Request to Import Summary Sheet - Stone				
Date Of Request	Material	Amount Requested (yds ³)	Source	Date of Agency Approval
8/12/2021	#57 Stone	2,500	Hawbaker Lawrenceville Quarry	8/12/2021
4/26/2022	#57 Stone	2,000	Hawbaker Erwin Quarry	5/2/2022
4/26/2022	#3 Stone	5,000	Hawbaker Pleasant Gap Quarry	5/2/2022
6/2/2023	#1 Stone	2,000	Steele Pit (Corning)	6/6/2023
6/2/2023	#1/#2 Stone Mix	4,000	Steele Pit (Corning)	6/6/2023
6/2/2023	#3/#4 Stone Mix	3,000	Steele Pit (Corning)	6/6/2023

From: Bonsteel, Nicole M <nicole.bonsteel2@woodplc.com>
Sent: Thursday, August 12, 2021 1:34 PM
To: Kaitlin Ouverson; Schneider, Timothy A (DEC)
Cc: Aron Krasnopoler; Paul Brookner; Melonie MacLaughlin; Bogardus, Sara (HEALTH); Stelmach, Mark J.; Howe, Alexander; Shields, Lindsey; Glowark, Brandon; Etter, Terry R.; Ian Masone; Miranda Stelmach; Andrew Millspaugh; Amanda Castignetti; Tom Johnson
Subject: RE: NYSDEC #c808022 - Request to Import #57 Hawbaker Stone (NAF STRA)

Request to Import/Reuse Fill or Soil

GRAIN SIZE DISTRIBUTION TEST REPORT
ASTM TEST METHODS: C136, C117, D2487

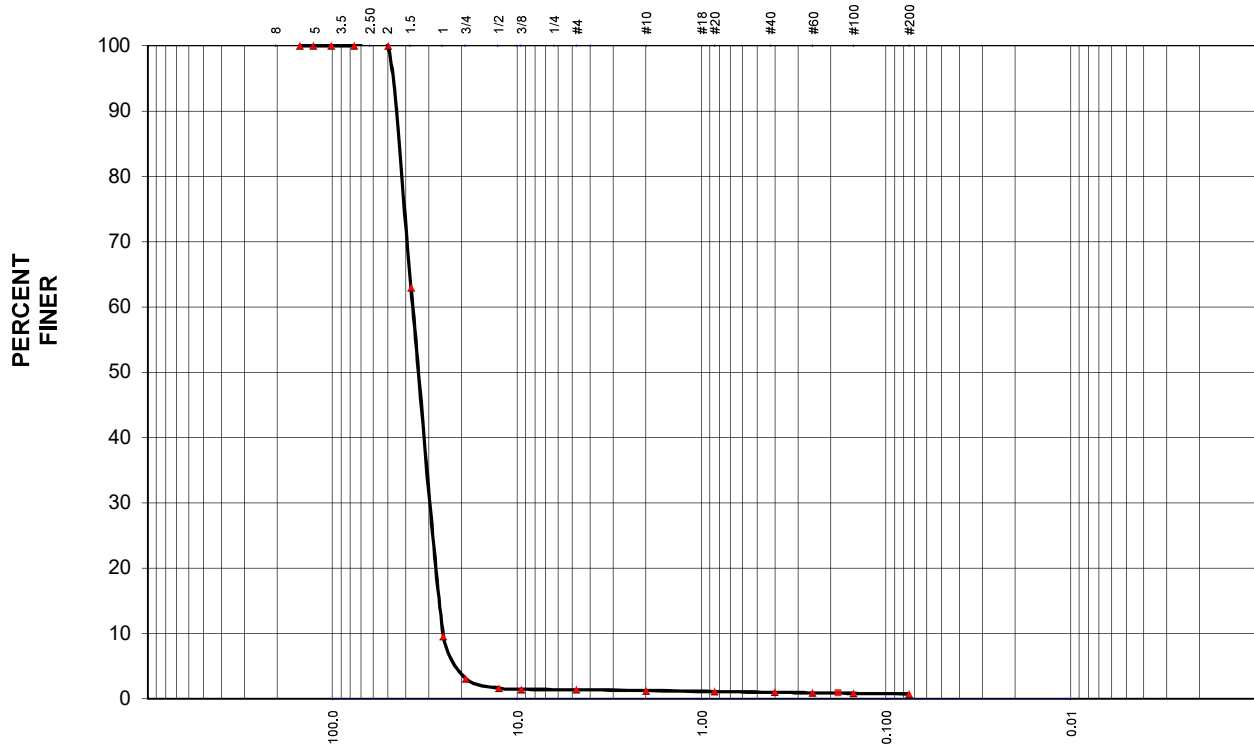
There are, however, discrepancies in the submittal that need to be corrected before backfill approval can be issued. Please address the discrepancies / missing information noted below.

For the #57 stone request to import:

1. The laboratory sieve analysis states that the source is Pleasant Gap Quarry while the signed request form indicates that the source is the Lawrenceville Quarry.
2. The virgin source documentation refers to 2A aggregate material, not #57 stone.

For the #3 stone request to import:

1. Information documenting that the Pleasant Gap Quarry is a New York State approved aggregate source has not been submitted.

1. The source for the #3 stone is Pleasant Gap Quarry. A revised sieve analysis report is attached. We are working with the quarry to provide documentation that it is NY approved aggregate source.
2. The proposed source for the #57 stone was Lawrenceville Quarry. Documentation that it is a virgin source and a NY approved aggregate source is attached.
3. We have been informed that Lawrenceville Quarry cannot provide #57 stone at this time. Erwin Quarry has been proposed as alternative source. Documentation that it is a virgin source and a NY approved aggregate source is attached. Samples are being collected for sieve analysis and a new request to import will be submitted for Agency approval.

The % passing #80 sieve (0.180 mm) is interpolated to be 0.83 based on the % passing #60 and #100 sieve.
